New Britain Township

CONDITIONAL USE HEARING APPLICATION

Rvw #2

Reference: Celek Chalfont, LLC – Conditional Use Review 2
241 W. Butler Avenue, TMP #26-013-032

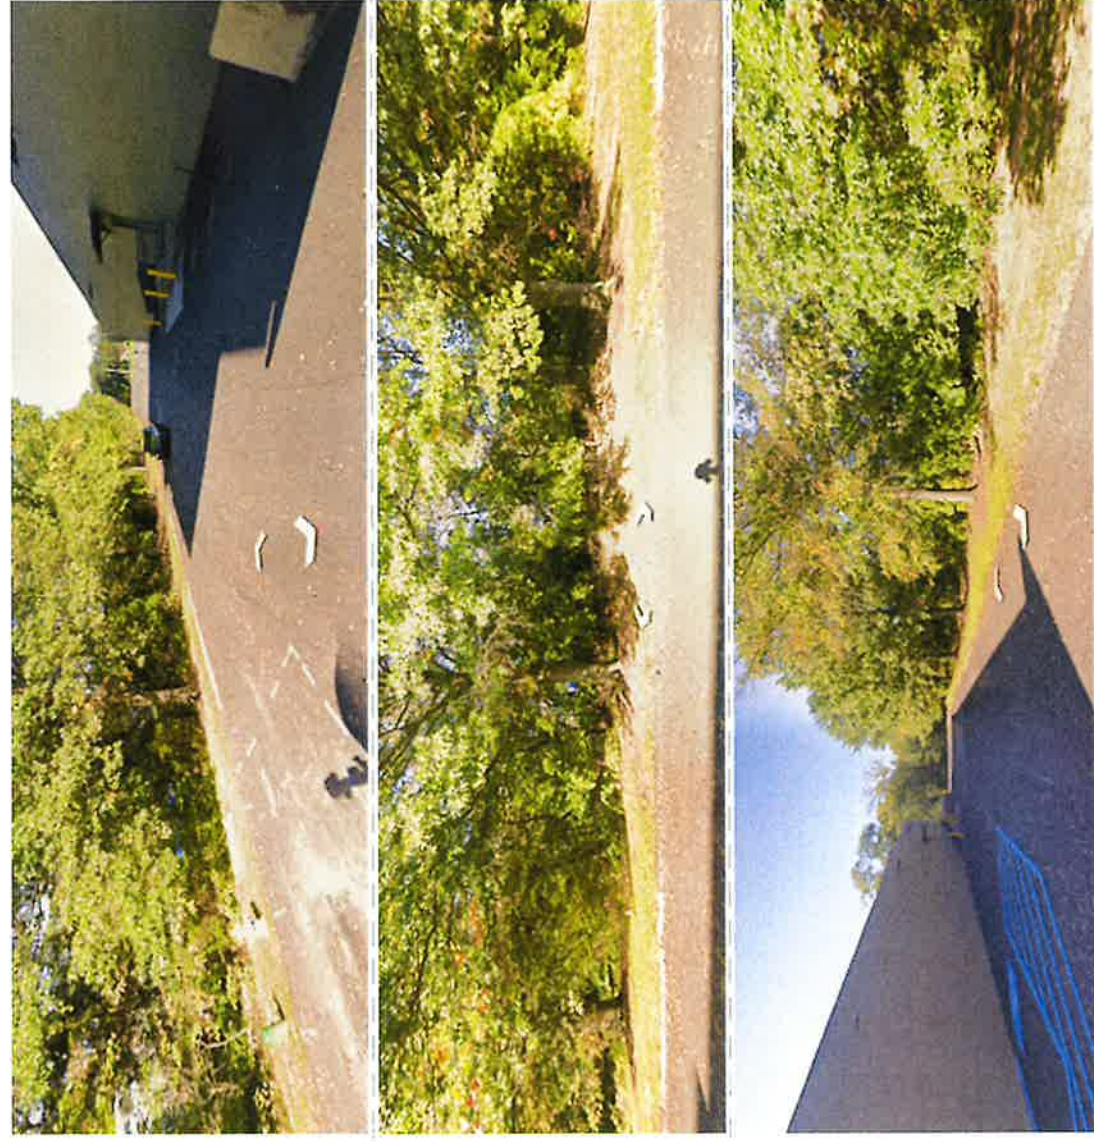
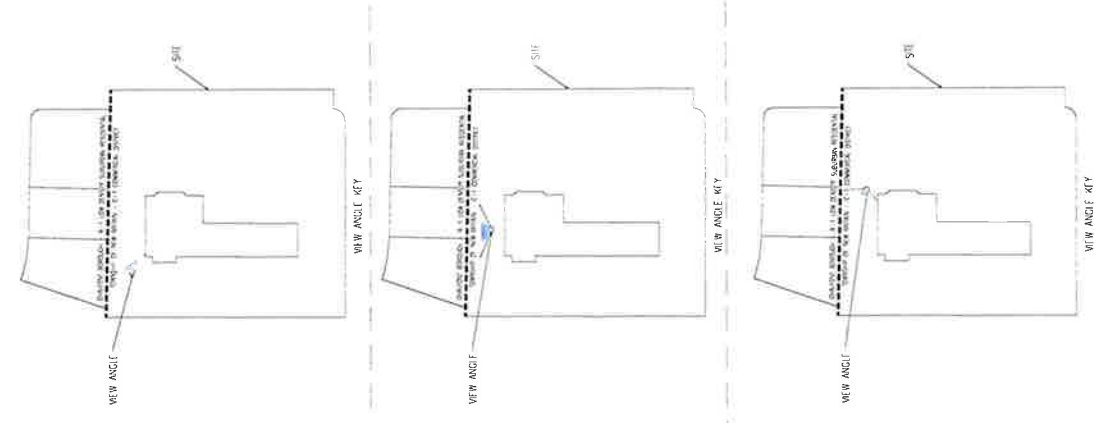
1. §27-305.L.L2. – Outside storage areas shall be shielded from view from all public streets. The plans show the outdoor storage areas screened with 8' chain-link fence with privacy slats. The Applicant has indicated that they will present renderings of the fencing to the Township.

3. §22-722.4.E. – All parking areas, walkways, and passages shall be adequately illuminated with a lighting system. The Applicant has requested a waiver from this requirement, stating the lighting is an existing non-conformity and due to the scope of work. We recommend that adequate lighting be provided for all outdoor storage area accessible to the public.

4. §27-2401.a.3 – The Natural Resource table on Sheet 2 shall be revised to document the woodlands area at the rear of the property.
5. §27-3008.e. – The applicant is required to submit an Environmental Impact Statement (EIS) in support of the conditional use application as specified in Part 2, § 27-201, Appendix A. The Applicant indicated in the Response letter dated June 13, 2025, that an EIS should not be required based on the scope of work. In addition, the Response letter dated June 13, 2025, the Applicant understands that the proposed improvements are in accordance with an existing environmental covenant over the property.

TREE BARRIER EXHIBIT

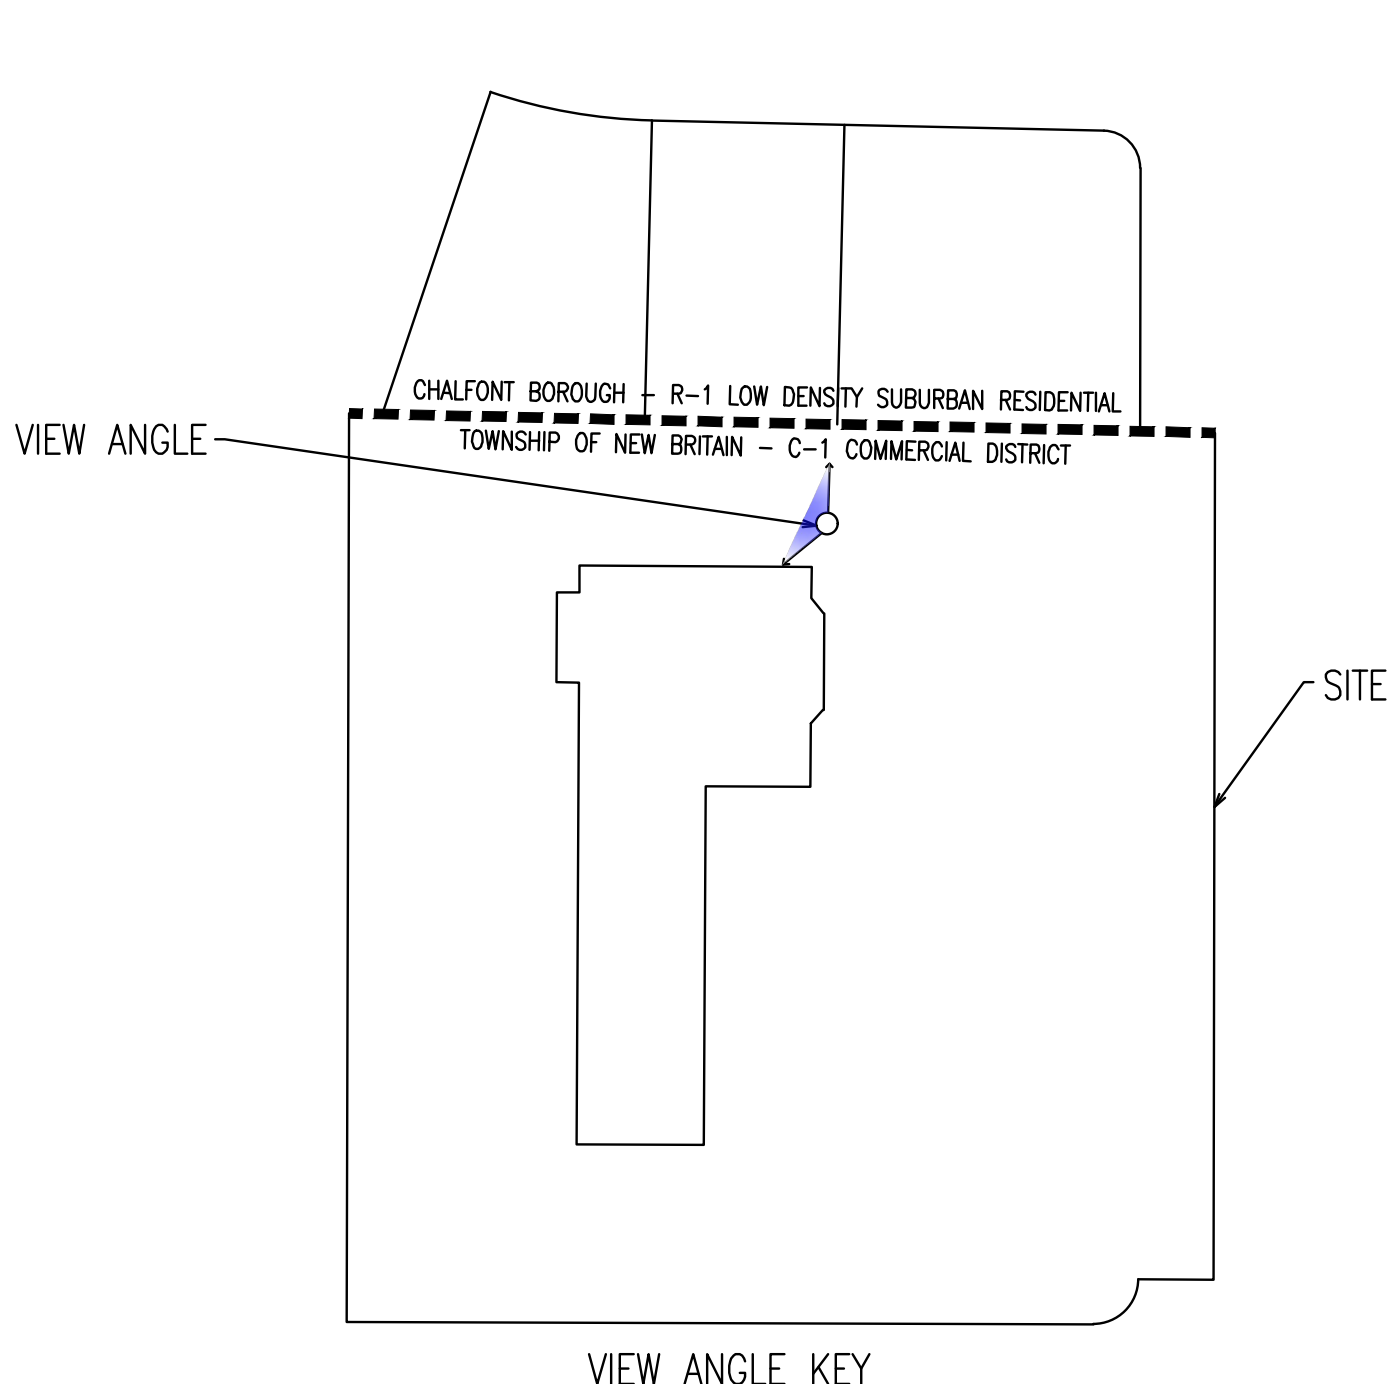
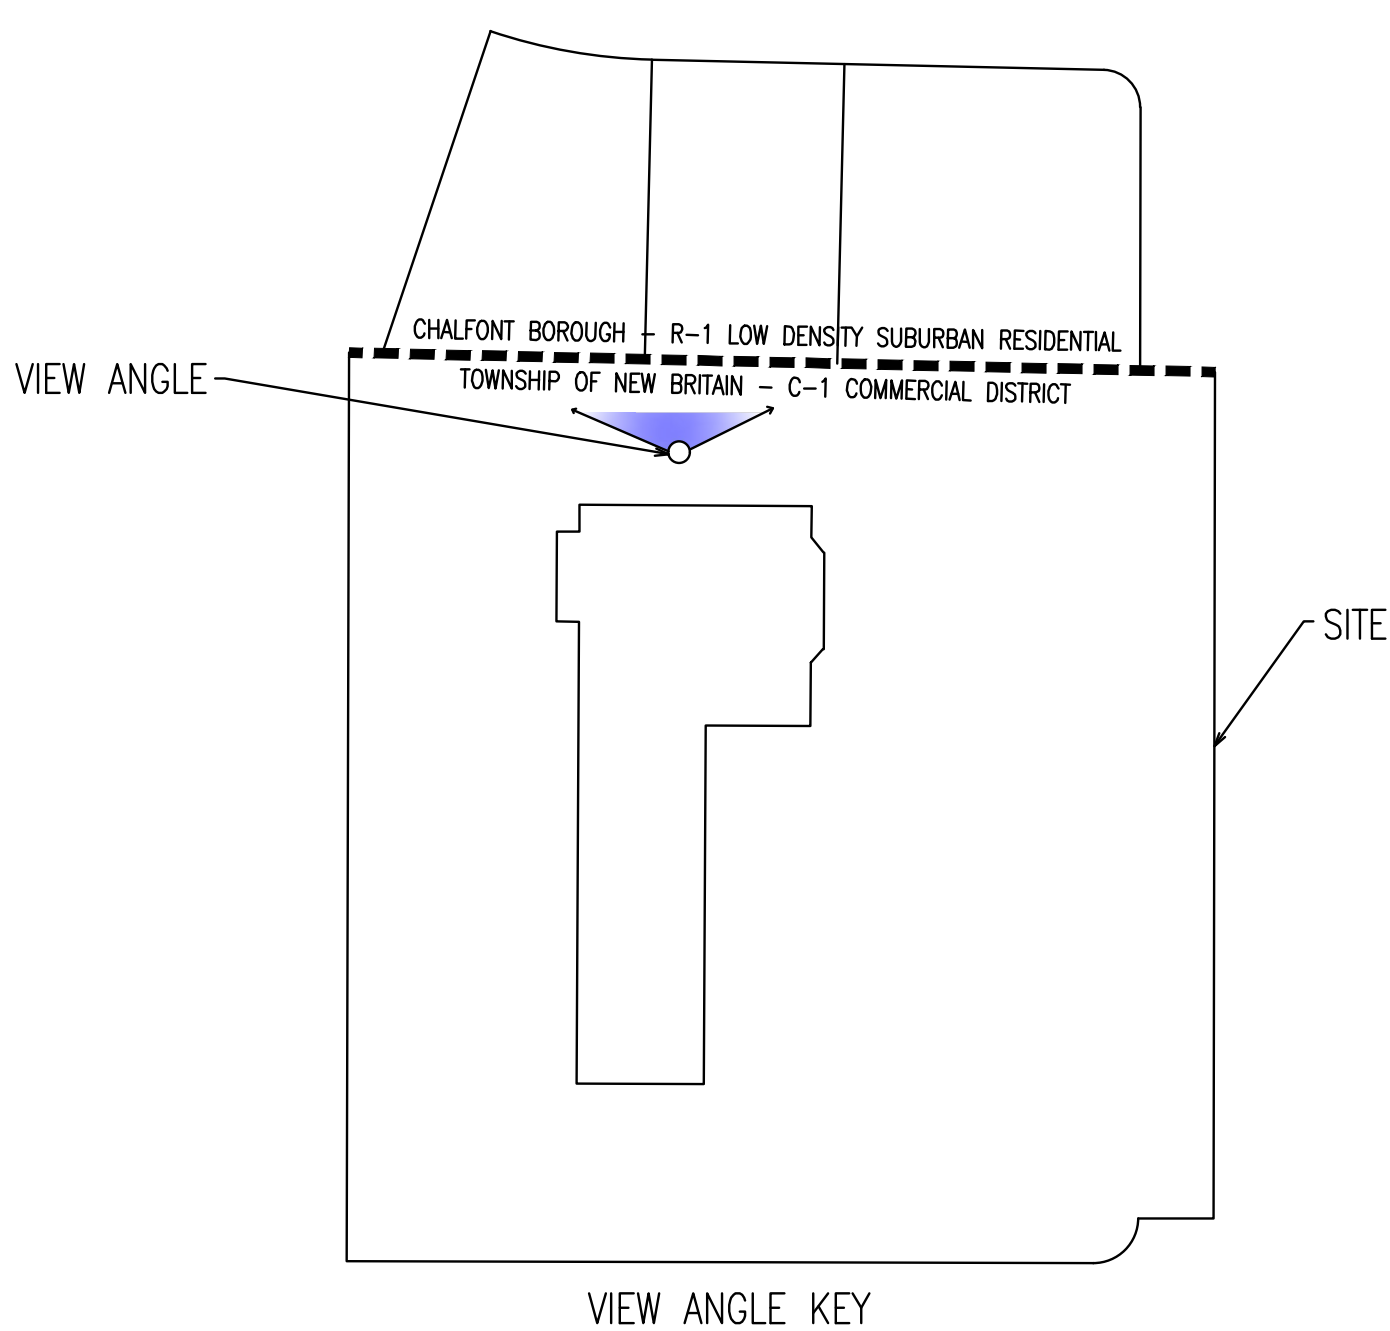
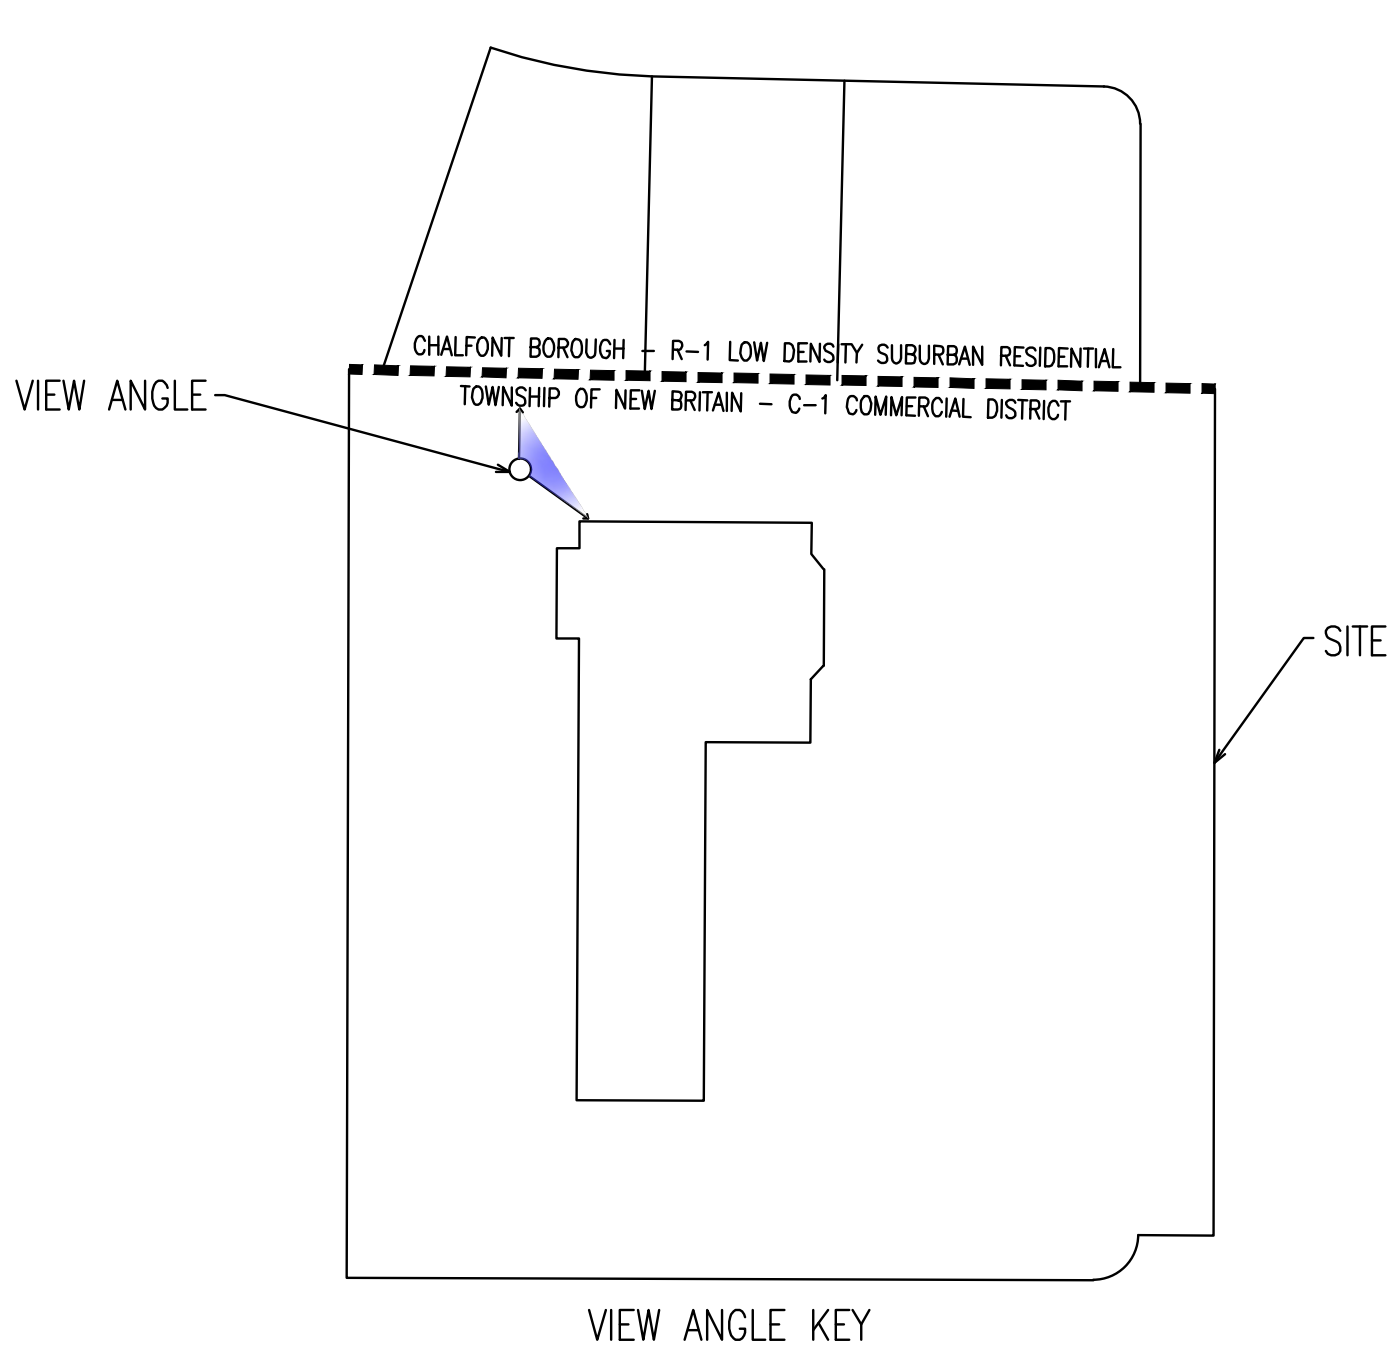
4. *Comment: §27-2800 – We recommend the condition of the existing property line buffer be assessed, maintained and supplemental plantings provided if there are gaps along the property lines shared with residential properties.*

Howell Response: The condition of the existing property line buffer between commercial and residential districts has been assessed and deemed that the current vegetation effectively serves the purpose of a visibility shield between the underlying districts. In response, Howell has prepared sheets C03.0 and C04.0 showing the view towards the residential properties.
